WATTS BAR NUCLEAR PLANT (WBN) - NUREG-0737 ITEM II.D.1, RELIEF AND SAFETY VALVE TESTING (TACM79992)

TVA RESPONSE TO NRC QUESTIONS DATED 10/10/91
RELIEF AND SAFETY VALVE TESTING

REQUEST FOR ADDITIONAL INFORMATION
WATTS BAR NUCLEAR PLANT, UNITS 1 AND 2
DOCKET NUMBERS 50-390 AND 50-391

Isometric Sketches of Model Used for Structural Analysis

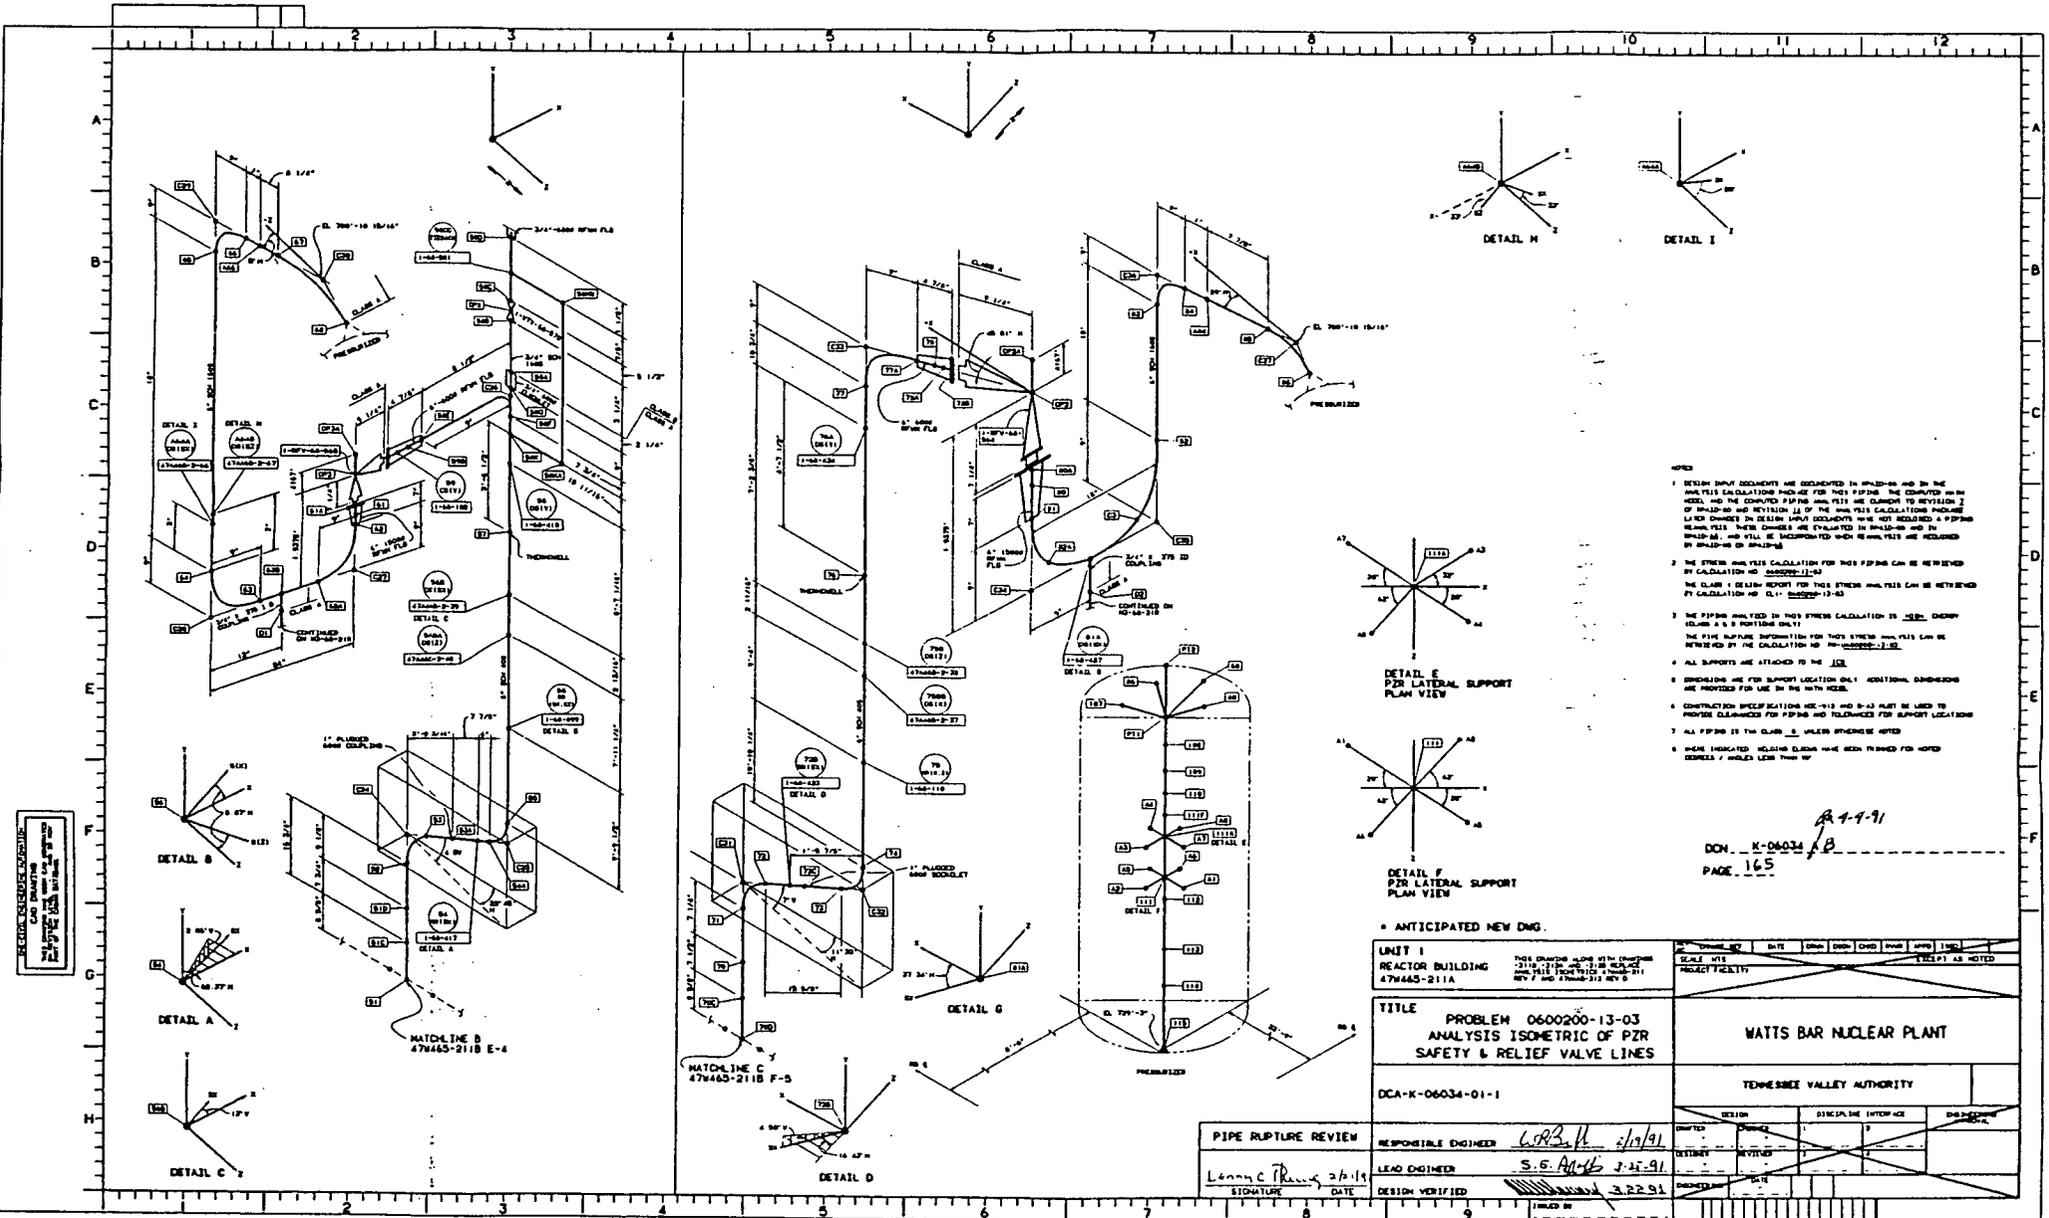
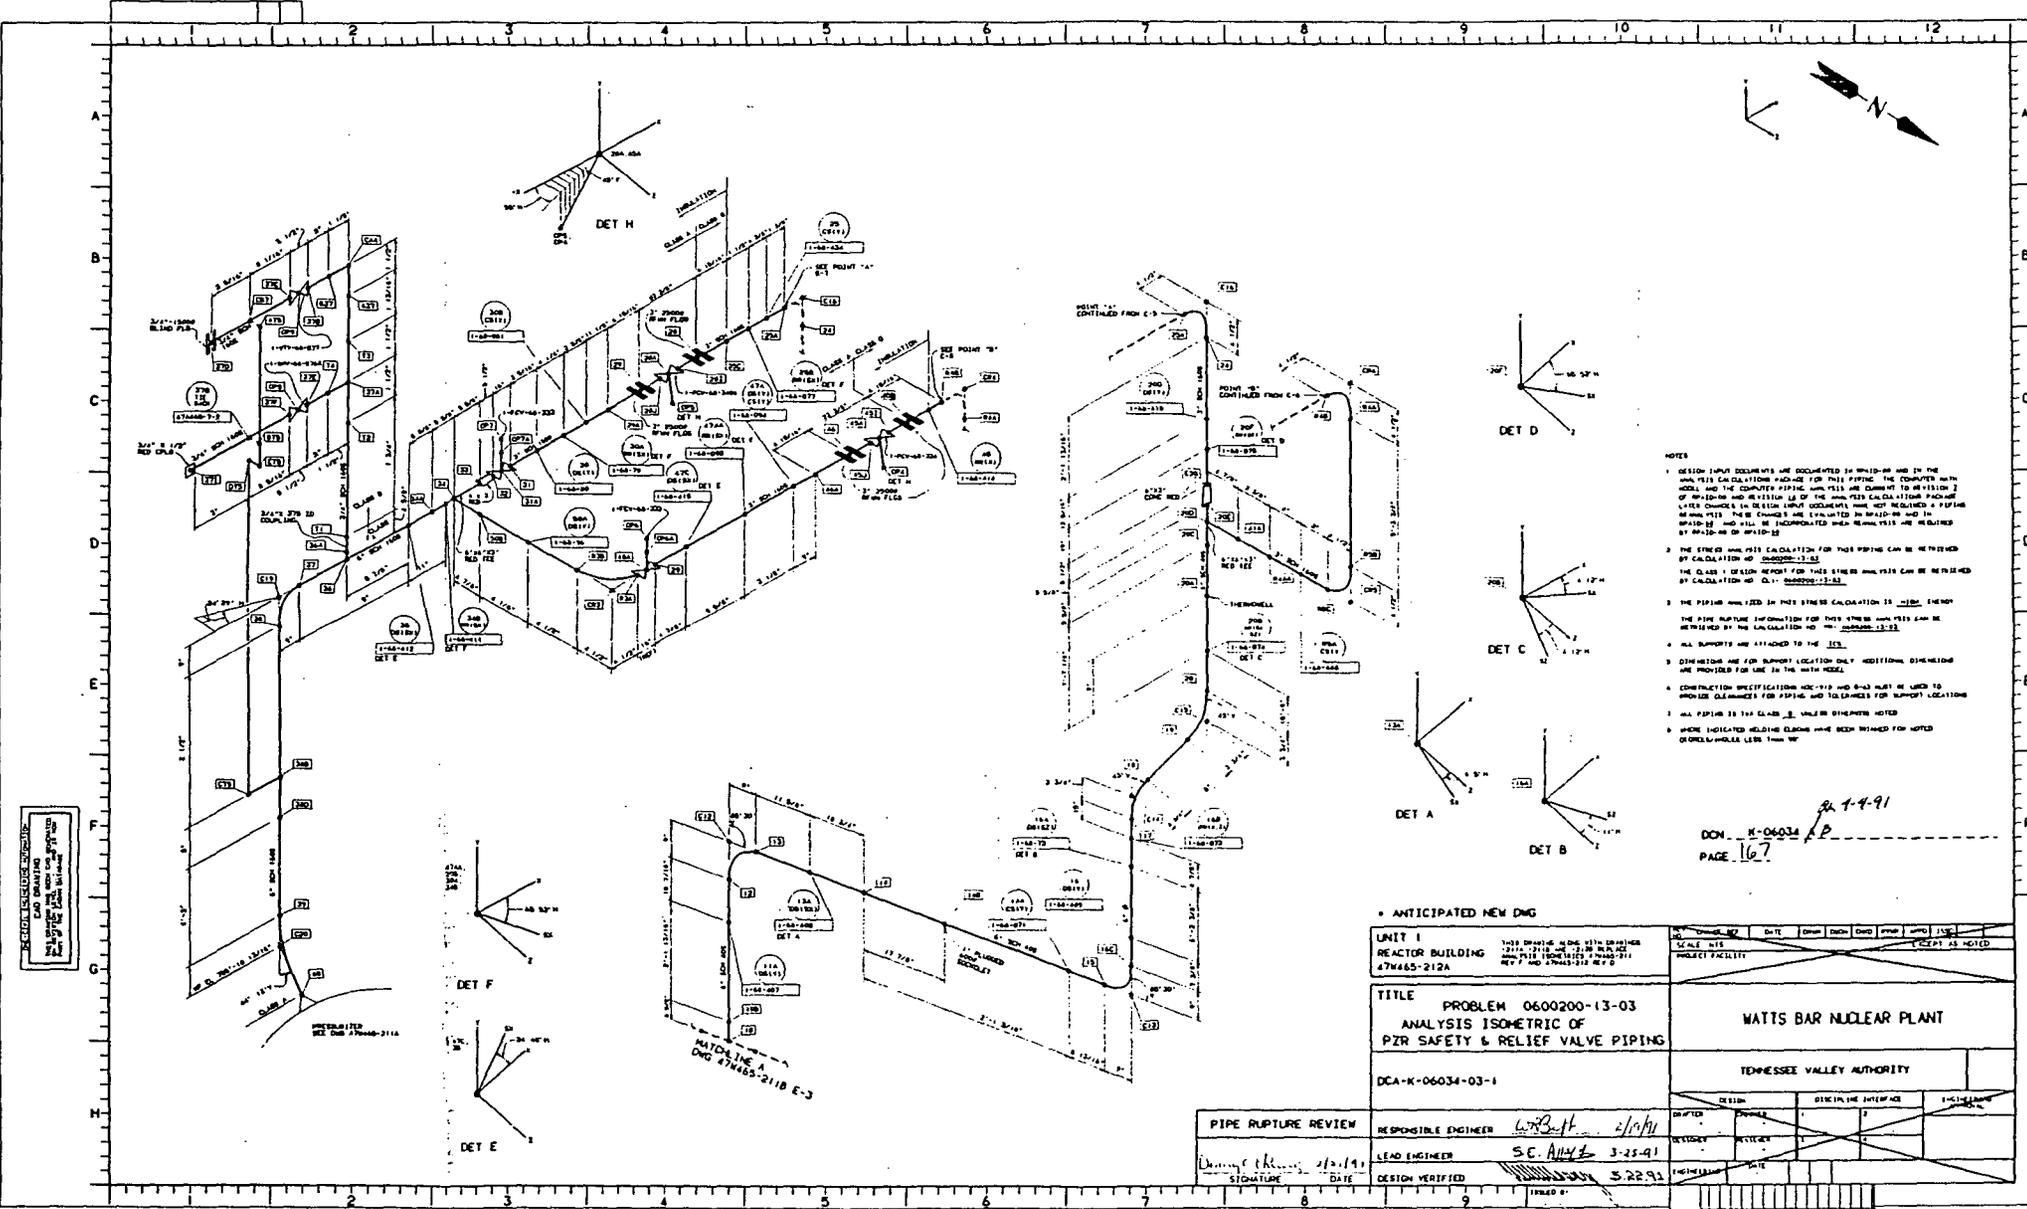
- F. Provide a sketch of the structural model showing lumped mass locations, pipe sizes, support locations, and application points of fluid forces.

- E. The stresses and loads for the PSV and PORV nozzles were determined in TVA Calculation WCG-ACQ-0351 (Reference 20). These stresses and loads were evaluated both by TVA personnel who were familiar with component qualification and by Westinghouse. The stresses and loads were found to be acceptable.
- F. The requested sketch of the structural model is shown on the analysis isometrics in Enclosure 7. These isometrics also show the piping and segment application points for the fluid forces.
